9. Fairness

9.1 Fairness scenarios

This subclause attempts to show that the current fairness protocols have not adequately addressed the possible effects of classC traffic on (intended to be) higher precedence classA and classB traffic. The subannex is formatted for inclusion in Clause 9, for the convenience of the reader. This contribution editor is primarily concerned with clarity, correctness, and availability. The final placement of this content could be Clause 9, an annex, or a working-group presentation.

Figure 9.1—ClassA0 blockage scenario

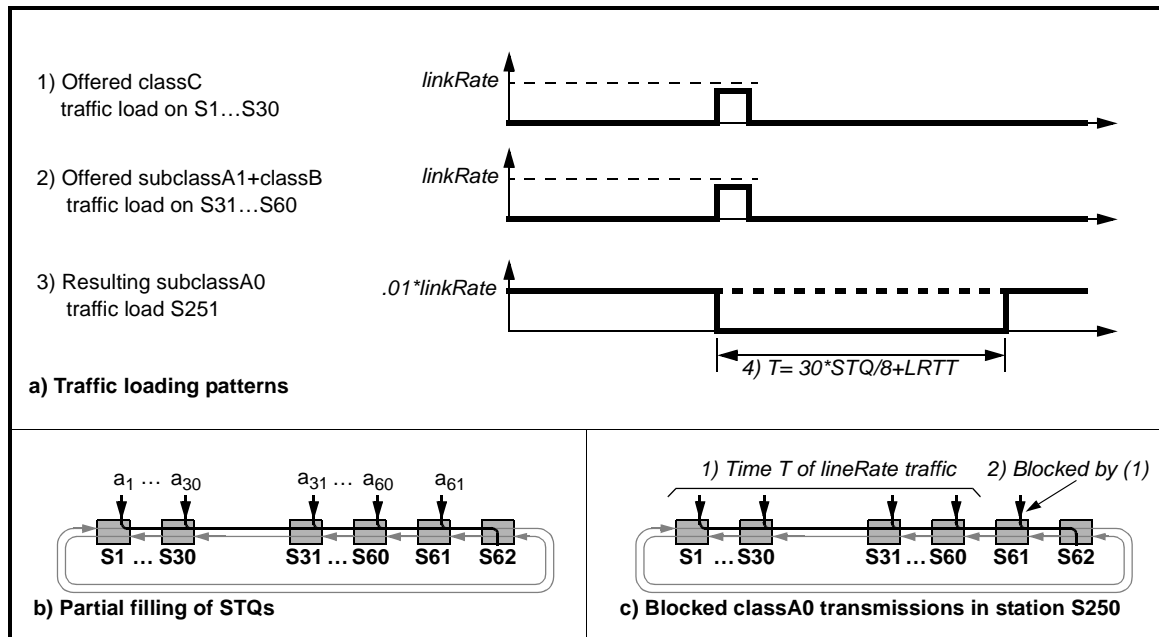
To illustrate potential STQ filling problems, consider the traffic loads of Figure 9.1a applied to topology of Figure 9.1b, leading to the classA0 bandwidth guarantee failure of Figure 9.1c. For this illustration, assume:

With an unfortunate timing of the offered $a_{31} \dots a_{60}$ add traffic, their STQs can fill to the low threshold (1/8 of the STQ) before a congestion condition is communicated. An additional delay of LRTT occurs before the cumulative upstream classC traffic from $a_1 \dots a_{30}$ can be stopped. As a result, the cumulative fill levels of the S31...S60 queues equals a time duration $T = 30 * STQ / 8 + LRTT$.

There is no downstream shaper on the S31...S60 STQs, they continue to transmit at the *linkRate* until their STQs have emptied. Thus, the downstream S62 station is blocked for at least the duration T , which directly effects the worst case classA0 traffic jitter. The LLRTT delays are significant; for large buffer sizes, the STQ related delays become intolerable.

The classA0 blockage was caused by the partial filling of upstream STQ buffers, allowing the upstream stations to effectively exempt the transiting traffic from downstream shapers. Two types of solutions are therefore possible:

- a) Revise the transmission protocols, so that upstream STQs are never filled.
- b) Improve the effectiveness of the downstream shaper, so that STQ traffic is no longer exempted.

The viability of a type (b) solution viable and validation proofs are manageable: the downstream shaper is applied to all conflicting traffic: STQ and added classB, in addition to added classC. There is no need to limit the added classA1 traffic, since subclassA0 and subclassA1 traffic have equal precedence.
